**APPLICATION NO. A/NE-TK/837 FOR PERMISSION
UNDER SECTION 16 OF THE TOWN PLANNING ORDINANCE**

Annex 1 - Response to Comments Table

Section 16 Application for Temporary Public Vehicle Park (Private Cars Only) with Ancillary Electric Vehicle Charging Facilities and Ancillary Solar Panels and Associated Filling of Land for a Period of 3 Years at Lot No. 241 in D.D. 23 at Ting Kok, Tai Po, New Territories

Annex 6 : Drainage Proposal

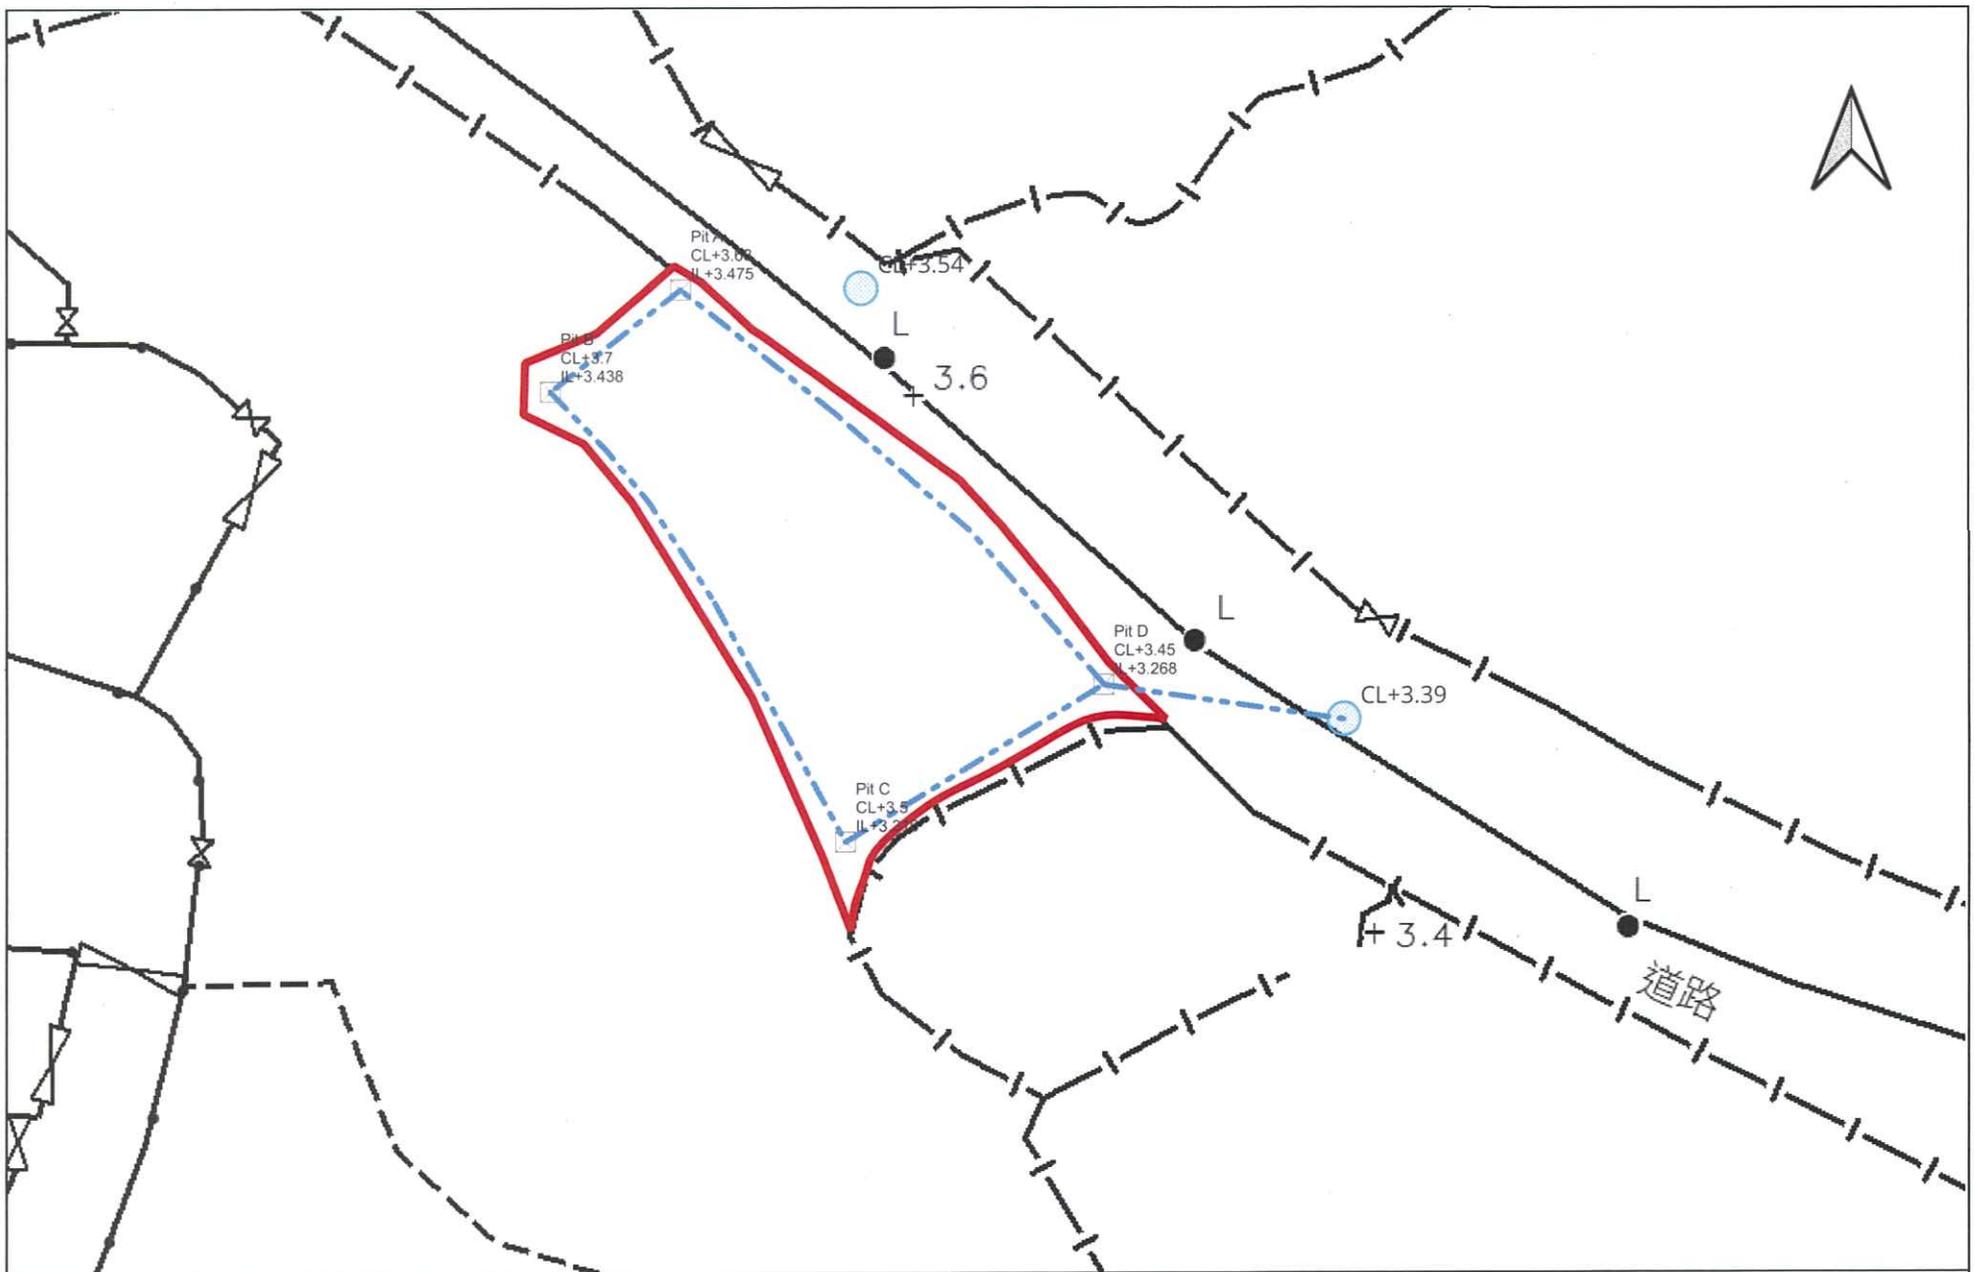
c	Surface channels should be provided along the perimeter of the site to collect all the runoff generated from the site or passing through the site, and discharge the runoff collected to a proper discharge point.	Noted, a preliminary drainage plan is provided in Annex 6 .
d	The catchment area appears underestimated.	Noted, a preliminary drainage plan is provided in Annex 6 .
e	The rainfall intensity should be increased by 16% according to Table 28 of SDM Corrigendum No. 1/2022.	Noted.
f	Reduction in flow area should be taken in account in accordance with Section 9.3 of SDM.	Noted.
g	The drainage flow path from the drainage facilities within the Site to the public drainage system/streamcourse/sea/any recognized drainage facilities shown in LandsD map should be provided in associated with supporting site photos.	Noted, the supporting site photos are provided in Annex 6 .
h	Furthermore, I would like to draw the applicant's attention to the following general comments/requirements:	Noted.
